# Access Compliance Report

## Public Rights-of-Way

### (Curb Ramps)

| Intersection ID: 21411 | Main Street: MONROE_RD | Cross Street: SARDIS_RD_NORTH | Location: NW           |

| ADA ID: 1AC346BA0BAE   | Ramp Type: Para        | Initial Pass/Fail: Fail       | Overall Compliance: No |

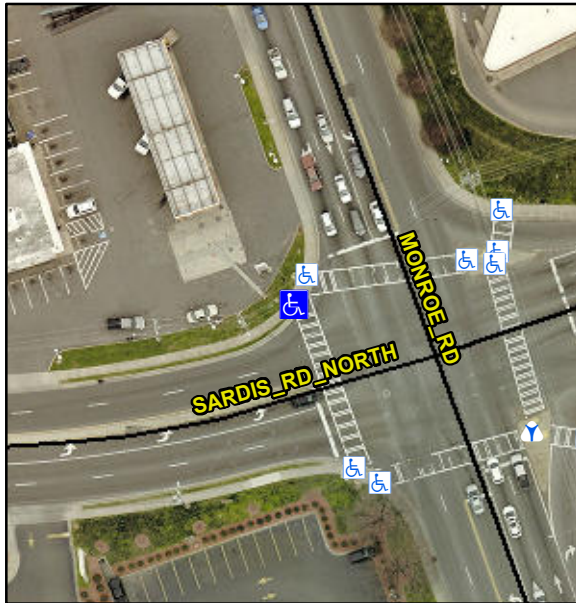
**R304.3.2**

| Compliance | Description          | Data  | Compliance | Description                 | Data |
|------------|----------------------|-------|------------|-----------------------------|------|
| No         | Ramp Slope LT (%)    | 8.5   | Yes        | Ramp Slope RT (%)           | 5.2  |

**Remove & Replace Entire Ramp.**
